**Project #19-035
Mill Creek
Located at 100 W 100 S**

Project Name: Mill Creek
Proponent / Owner: Jared Neilson / Mill Creek of Logan, LLC
Project Address: 100 W 100 S
Request: Design Review Permit
Current Zoning: Town Center 1 (TC-1)
Type of Action: Quasi-Judicial
Date of Hearing: September 12, 2019
Submitted By: Aaron Smith, Planner II

RECOMMENDATION

Staff recommends that the Planning Commission **conditionally approve** a Design Review Permit for Project #19-035, Mill Creek, for the properties located at 100 W 100 S, TIN# 02-046-0015,-0016.

DATE: Aug. 9, 2019
DRAWING NO: A-201.2

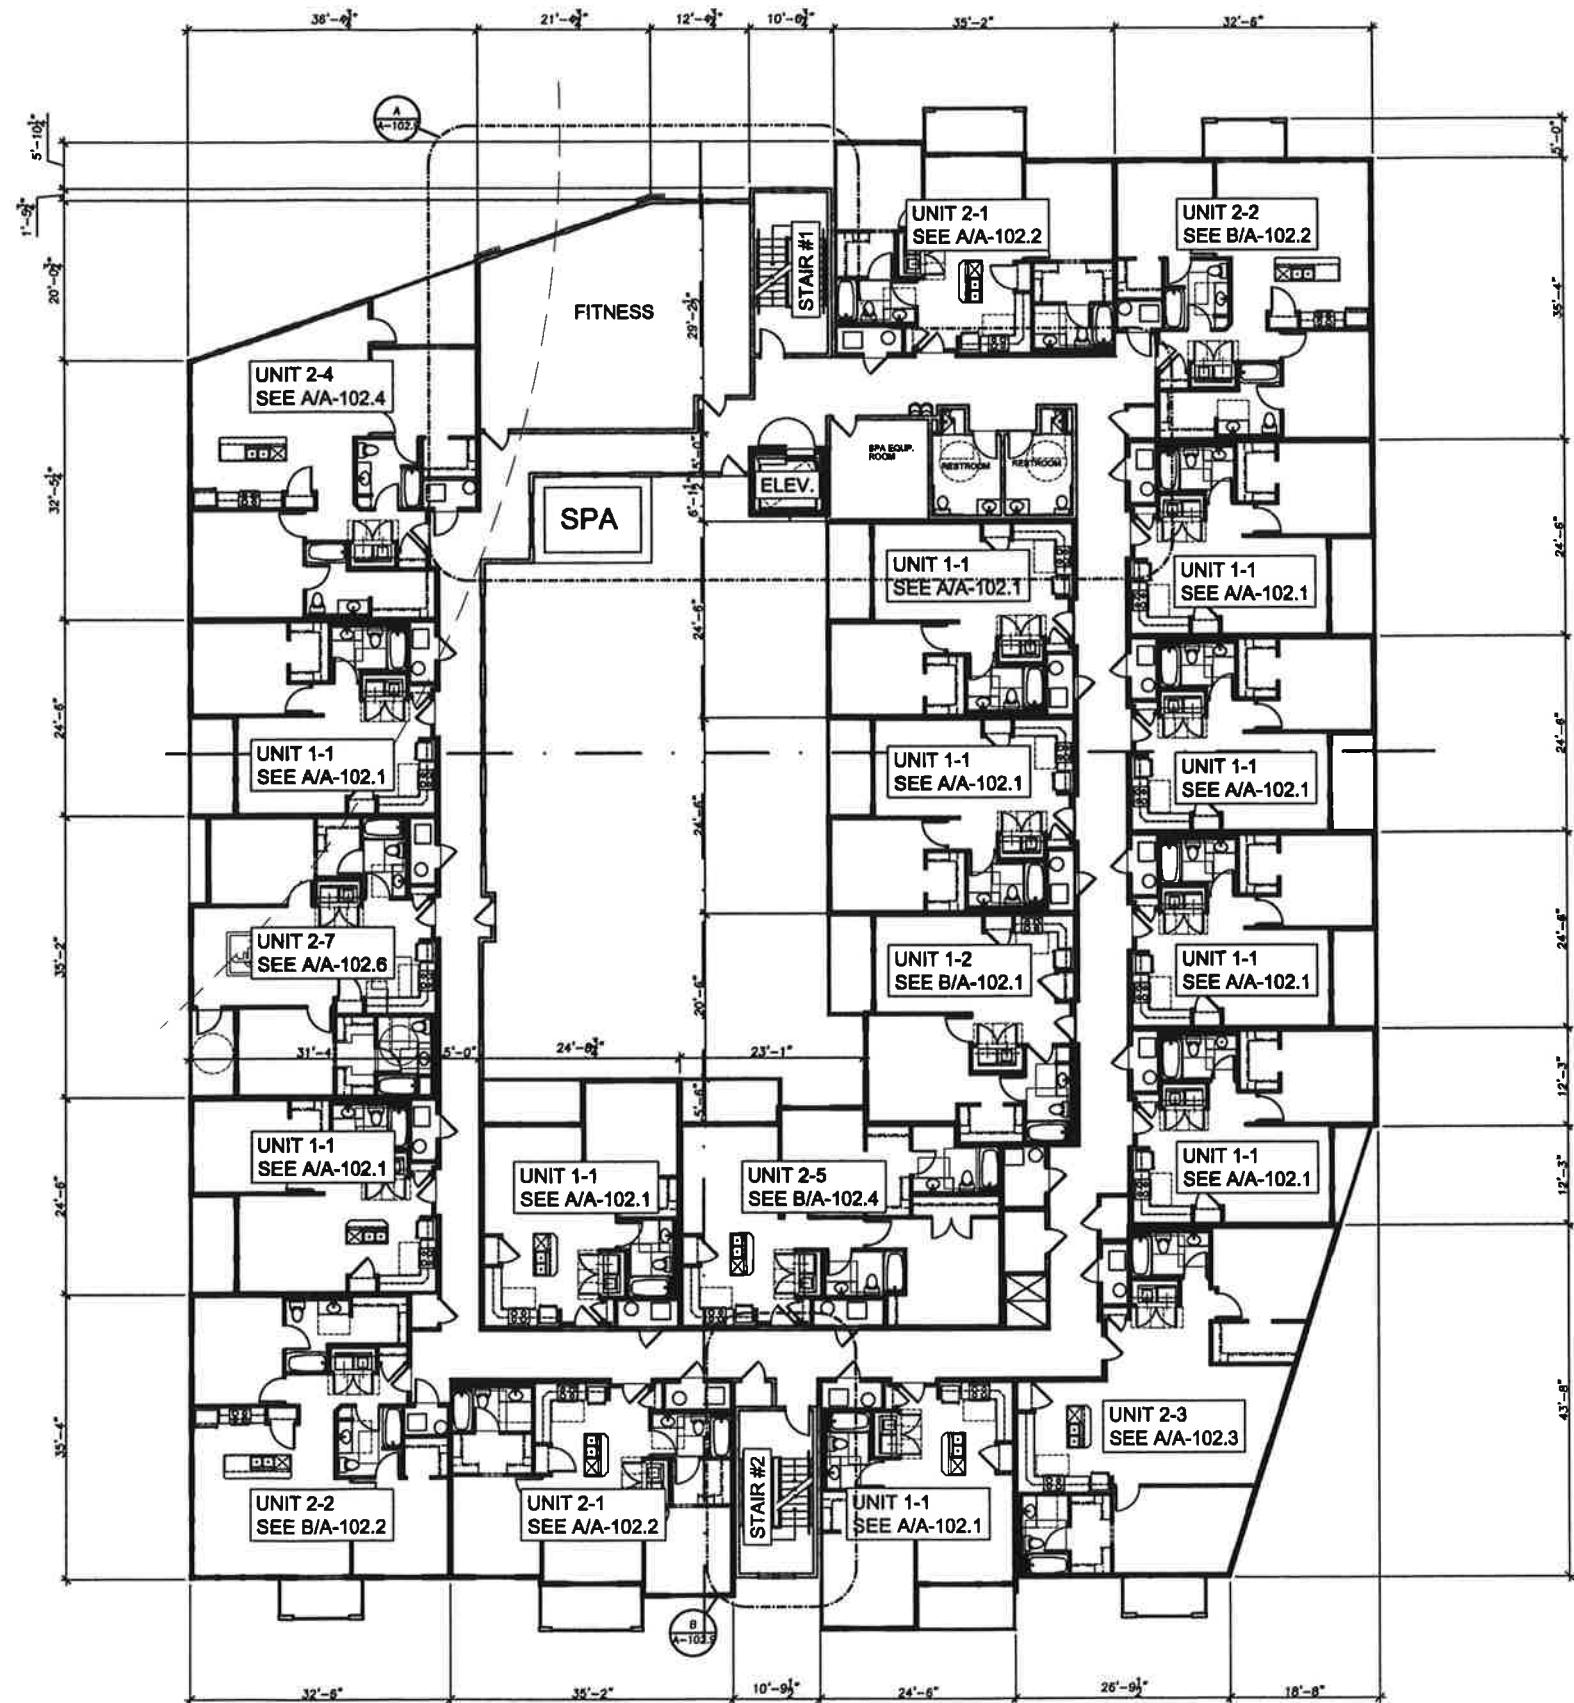
The transparency on the inhabited floors are all compliant with the LDC. Many of the ground floor areas that are primarily structured parking are not compliant with the code. The transparency code in the LDC generally specifies street facing or exposed sides as being of particular importance for meeting transparency requirements. As the TC-1 Residential Transparency requirement does not make a specification regarding exposed sides, the code has been interpreted by staff as applying to all sides of the building. It is within the Planning Commission's purview to broadly or narrowly apply the transparency requirement to apply to all sides or only the exposed sides, which would include the 100 S and 100 W street facing facades. As transparency is considered a design element of the building, the Planning Commission may reduce the requirement below 20%. As conditioned, with the planning commission requiring the 20% transparency requirement only on exposed sides, the project meets the requirements in the LDC.

The LDC requires 4-sided architecture that emphasizes similar architectural features on all sides of the building. The building's primary entrance and architectural emphasis is on the 100 S frontage. Repetition of materials, fenestration, and architectural details are repeated on the various facades. One area that lacks consideration is the southern portion of the east façade, both the parking lvl1 and lvl2 floors. This area includes a 48' and 71' blank wall. Blank areas of wall that are visible from a public right-of-way that exceed 40' are prohibited. Vertical detailing, including window/door breaks, changes in wall planes, change in texture/color/materials, or use of vertical elements, including vertical plantings, may be used to break up the façade in this

area. As conditioned, with either additional architectural features or landscape and screening to buffer the areas of the eastern wall, the project meets the requirements in the LDC.

SITE PLAN

17. All floors along street facing facades shall have a minimum transparency of 20%.
18. The east façade (parking structure section) that is visible from the street and has blank wall sections of 40 feet or more shall either have additional architectural features or landscaping buffers planted to screen views.

**DESIGN REVIEW
SITE PLAN**

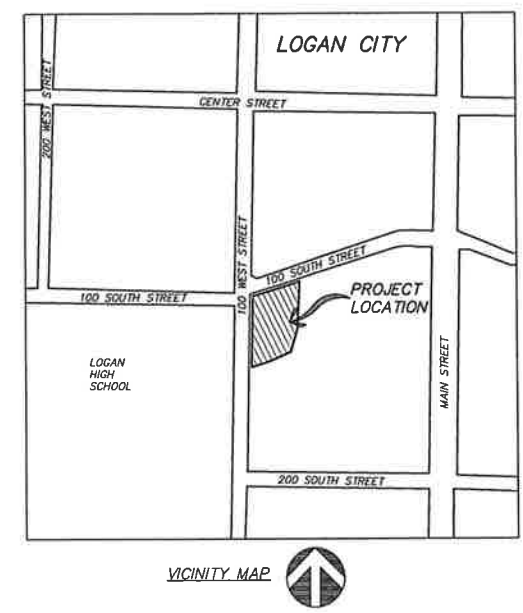
Front (100 S):	7.5' (2' after ROW dedication)
Front (100 W):	5'
Side (East):	8'
Rear (South):	10'
Parking (100 W):	2.9'

The need for dedication of public right-of-way (ROW) along 100 S may also impact setbacks, and reduce the front setback along 100 S from 7.5' to 2'. The surveyed property lines along this frontage show that much of the sidewalk and parkstrip are within the property boundaries. As conditioned, with the Planning Commission identifying findings consistent with a reduced building setback along 100 S and 100 W, the project meets the requirements in the LDC.

The proposed parking setback along 100 W is approximately 3' and is less than the 5' required for the zone. A simple solution to this would be to reduce the 20' parking stall length to the permitted 18' length. The additional 2' would meet the parking setback requirement. As conditioned, with the project meeting the 5' parking setback requirement, the project meets the requirements of the LDC.

The proposed structured parking includes 122 stalls (12 are compact stalls), the surface parking includes 14 stalls. The total parking provided for the project is 136. The LDC allows 10% of parking stalls to be compact stalls. Several of the parking stalls in the structured parking are double loaded, meaning that they are accessed through another parking stall instead of a drive aisle. This parking layout is permitted, but the double loaded stalls are required to be designated to the same dwelling unit so that movement of cars in the parking garage can easily be coordinated within a household. As conditioned, the project meets the requirements of the LDC.

5. The Planning Commission permits the setback along 100 S to be reduced to 2' as findings have been made to support a reduction of the 10' maximum setback for residential structures in the TC-1 zone.

6. The Planning Commission permits the setback along 100 W to be reduced to 5' as findings have been made to support a reduction of the 10' maximum setback for residential structures in the TC-1 zone.

7. The parking setback shall be 5'.
8. Right-of-way dedication or a public access easement shall be provided along 100 S so that all sidewalk and parkstrip is accessible to the public.

9. The project shall provide 134 parking stalls. 7 of the parking stalls shall be provided for visitors. Final parking totals subject to verification of unit count and configuration.

LANDSCAPE PLAN

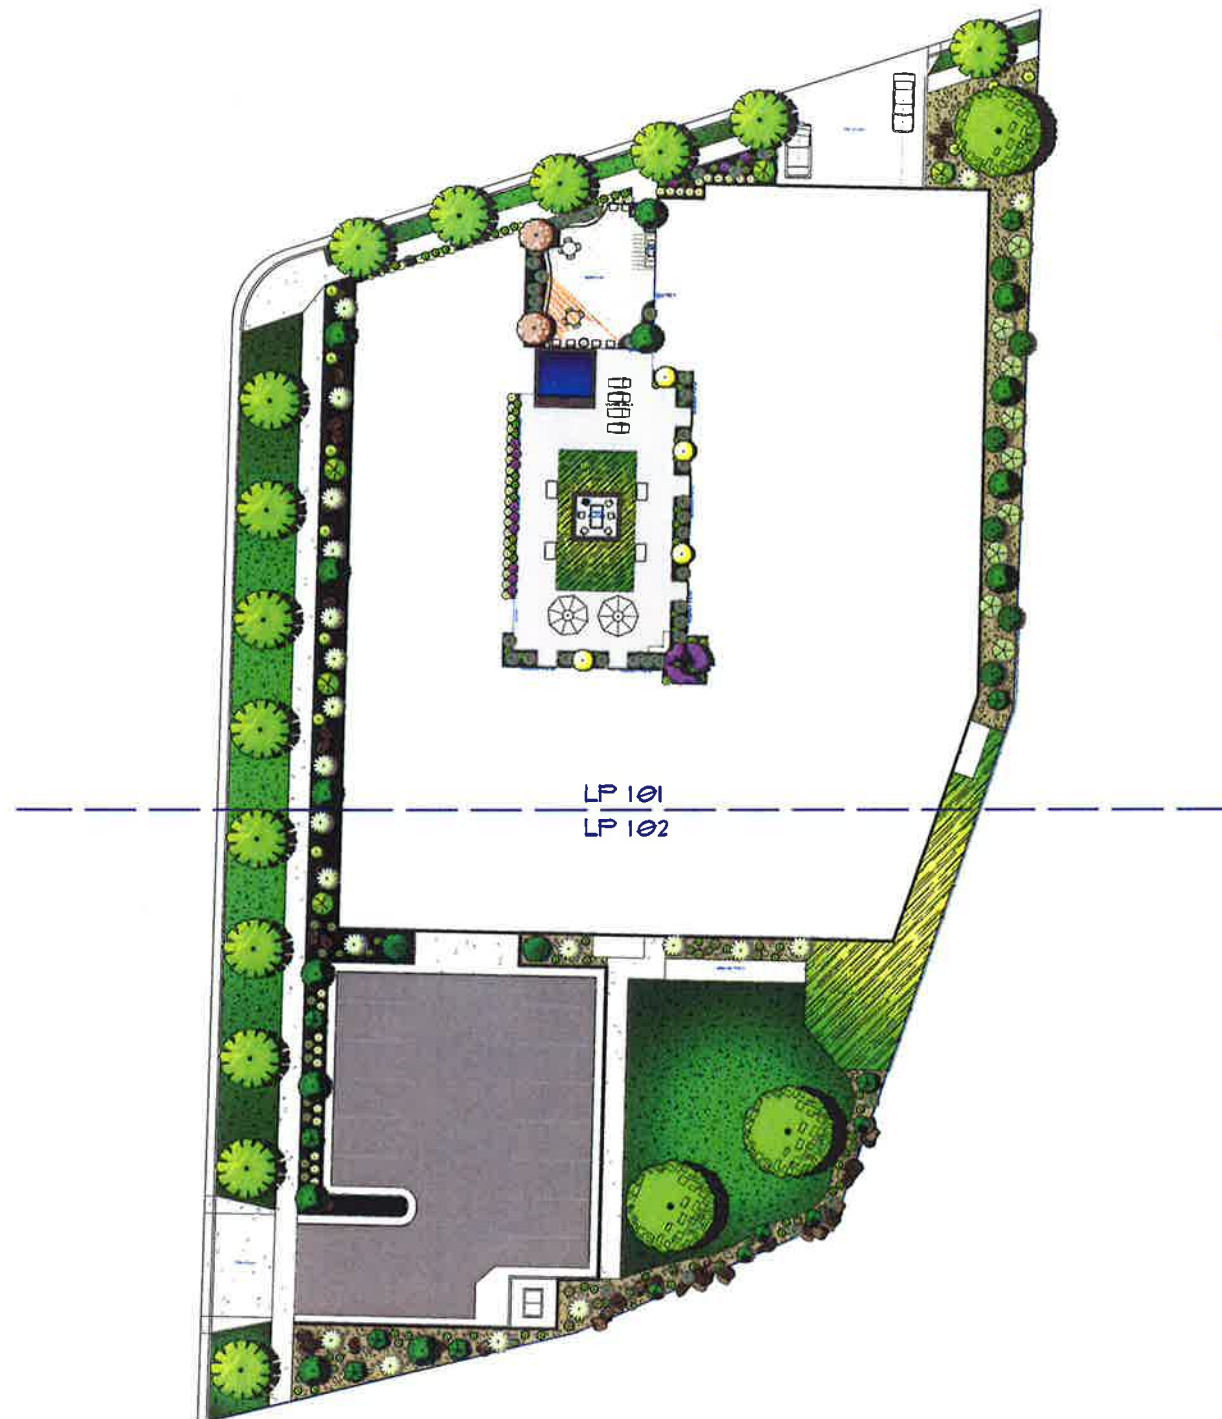
The LDC 17.32 requires minimum plant material for overall visual aesthetics, ecology, screening, and shading purposes. The LDC requires a minimum of 20 trees and a combination of 50 shrubs, flowers and ornamental grasses per acre of land in the COM zone. For the .94 acre project site, 19 trees and 47 shrubs, flowers and ornamental plants are required. The proposed landscaping plan includes landscaped areas around the building, parking lot, and roof top patio. In total 54 trees and 305 shrubs, flowers and ornamental plants are proposed. The design of the planting areas along both the 100 S and 100 W frontages, including columnar trees, will help to break up and buffer the ground level building facades and parking areas. Additional project landscaping includes a 6,661 SF turf area, and a 1,545 SF artificial turf area

that will serve as a dog park for residents. As conditioned, with a performance landscaping plan, the project meets the requirements in the LDC.

12. Double loaded parking stalls shall be assigned to the same dwelling unit.
13. A performance landscaping plan, prepared in accordance with §17.39 of the LDC and consistent with the proposed landscaping, shall be submitted for approval to the Community Development Department prior to the issuance of the building permit.

14. Street trees shall be planted along all adjacent streets at 30 feet on center.
15. Enhanced vertical landscaping that matches "Type C" in LDC 17.32.070 shall be placed in the areas between the sidewalk and the parking lot along 100 West.
